**EAST GOSHEN TOWNSHIP
PLANNING COMMISSION
Meeting Agenda
Tuesday, July 30, 2024
7:00 PM**

Date: 7-26-2024
To: Planning Commission
From: Duane J. Brady Sr., East Goshen Township Zoning Officer
Re: **1010 Hershey Mill Road / Millstone Meadows
Preliminary/Final Subdivision and Land Development
Residential Open Space Development/Third Submission Letter**

The Township Fire Marshal has reviewed the Revised Subdivision Plans dated June 7, 2024, for the creation of a new 14 Lot Residential Open Space Subdivision/Land Development and has the following recommendations and comments:

"MILLSTONE MEADOWS"
FINAL PLAN
PROFILES

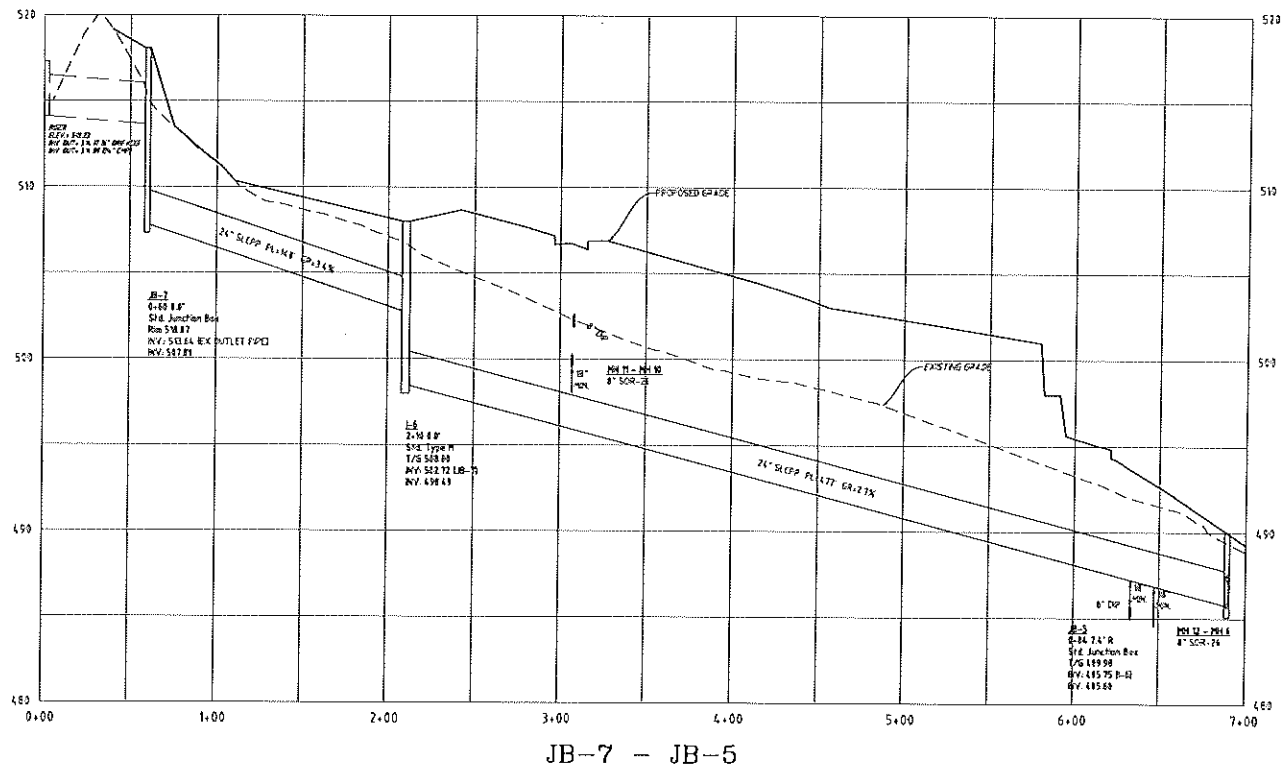
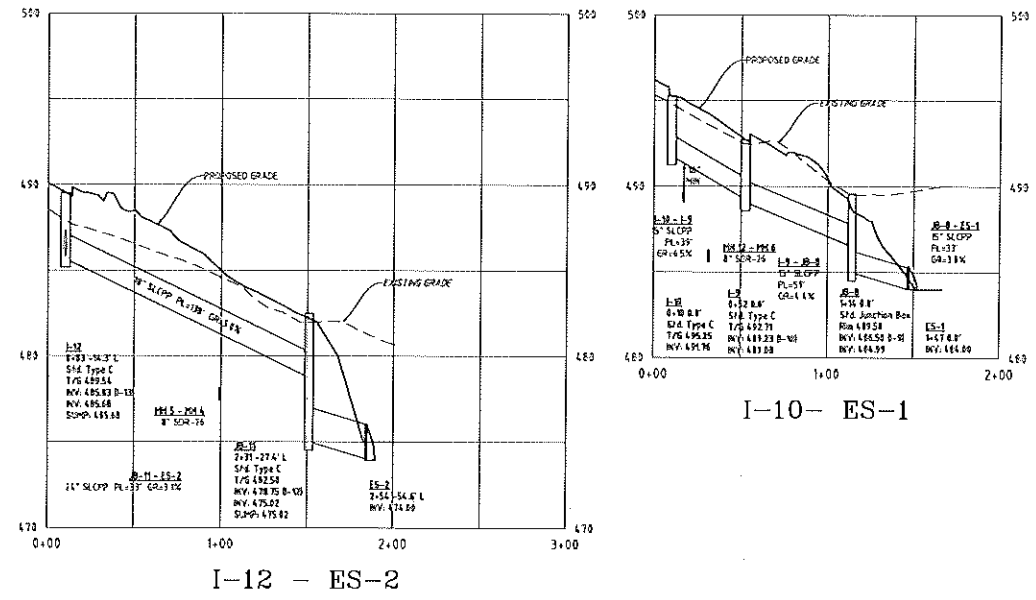
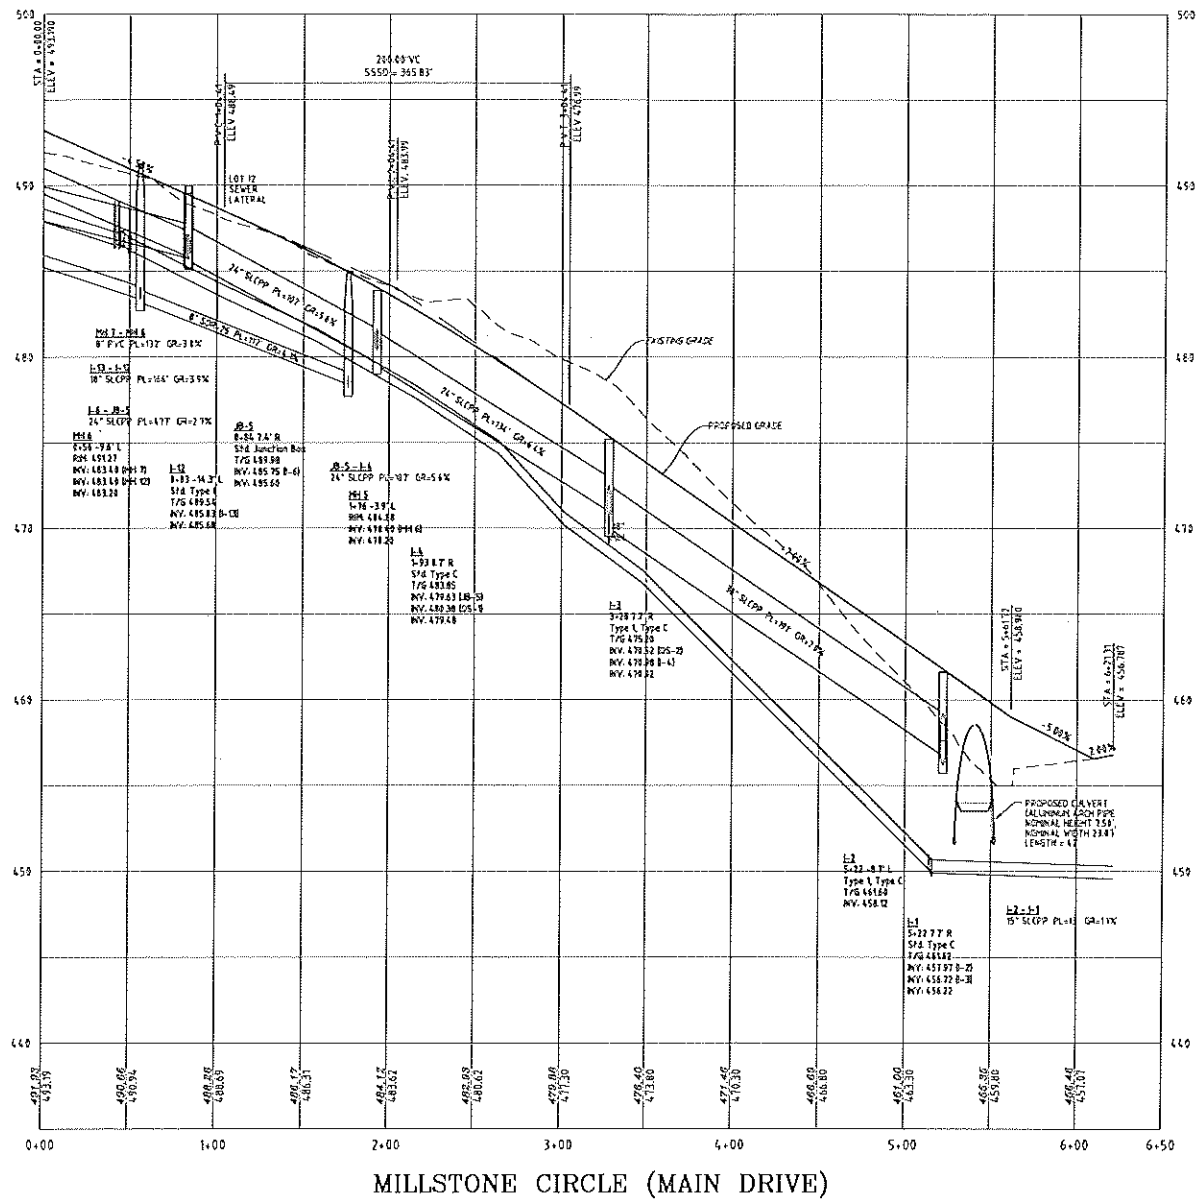
75. We recommend extending sewer from MH 11 through the easement, past the driveway, to the rear of Lot 6 so that future connections from the neighboring community will not require the demolition and replacement of curb and driveway of Lot 6. We recommend this extension have a cleanout near or at the end of the pipe extension to help locate the end of the pipe for future connection to the system.
Outstanding. The design engineer has indicated that this will be further discussed.
The requested sewer line has been added and a profile provided on Sheet 9.

INFILTRATION BASIN #1 CROSS-SECTION

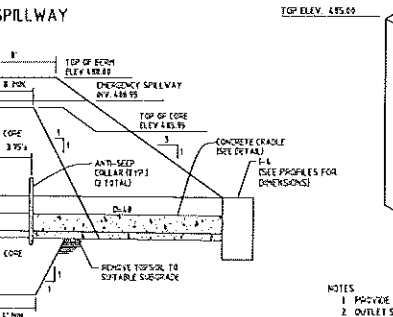
- d. The infiltration test in SW-1A was performed at 484.3'. The applicant should provide testing at the elevation of the proposed infiltration for Basin 1 elevation 483.0'. (§195-20.I(2))

Resolved. The bottom of Basin #1 was revised to 484.00 and a two-foot layer of amended soils has been included to provide infiltration separation. A note has been added to the plans indicating that additional soil testing at the time of conversion.

INFILTRATION BASIN #2 CROSS-SECTION

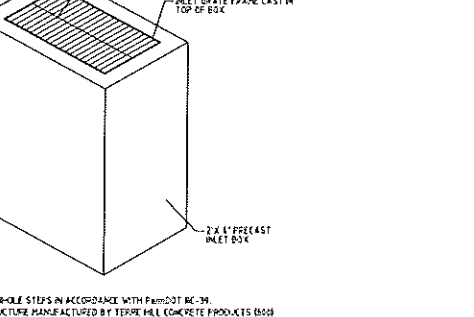
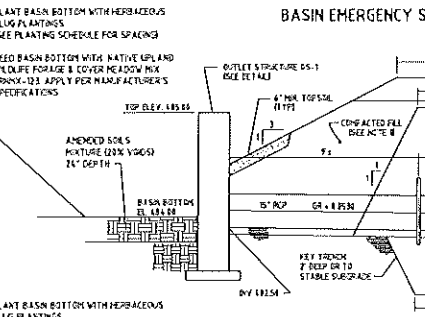
- e. The infiltration test in SW-2C was performed at 475.09'. The applicant should provide testing at the elevation of the proposed infiltration for Basin 2 elevation 473.0'. (§195-20.I(2))

Resolved. The bottom of Basin #2 was revised to 475.00 and a two-foot layer of amended soils has been included to provide infiltration separation.

WATERTIGHT MANHOLE FRAME AND COVER ASSEMBLY DETAIL
NOT TO SCALE

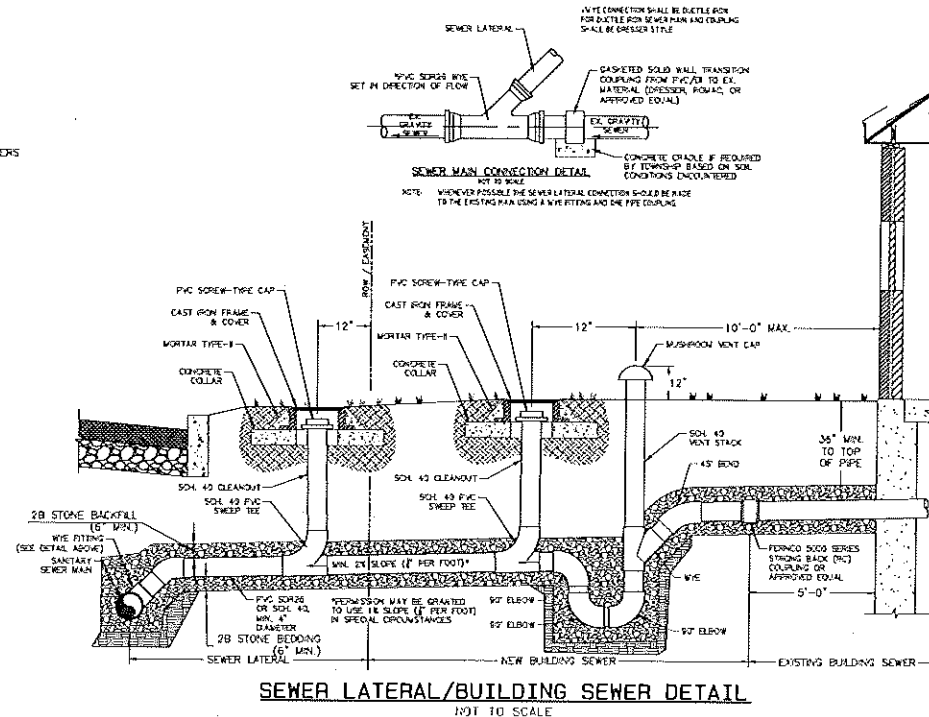
73. Watertight manhole frame and cover are to be revised per the attached detail. Top of manhole to say, "East Goshen Municipal Authority" and "Sanitary Sewer". Precast concrete adjustment rings that are less than or equal to 11.5-inches are to be used. Bolt down lids are to be used instead of locking bar (bolt down lids are not to be used for manholes located in pavement).

Resolved. The detail has been revised as requested.

SEWER LATERAL/BUILDING SEWER DETAIL
NOT TO SCALE

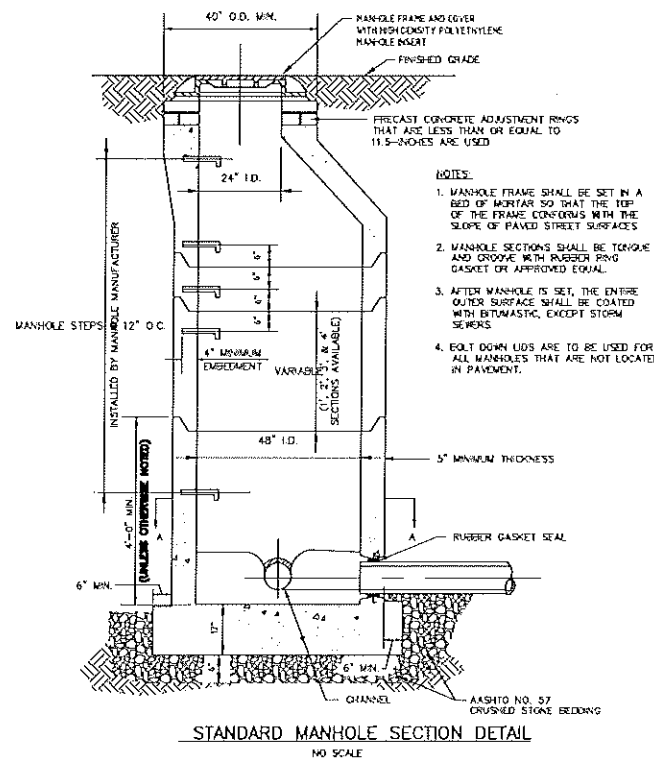
91. ***The Site Plan Legend references grinder pumps; however, the plan views imply that all sanitary laterals will be gravity per the Sewer Lateral / Sewer Building Sewer Detail on Sheet 19. Engineer shall clarify and revise the plans accordingly if the laterals will be gravity fed or use a grinder pump. If grinder pumps are to be used, additional information and details will be required.***
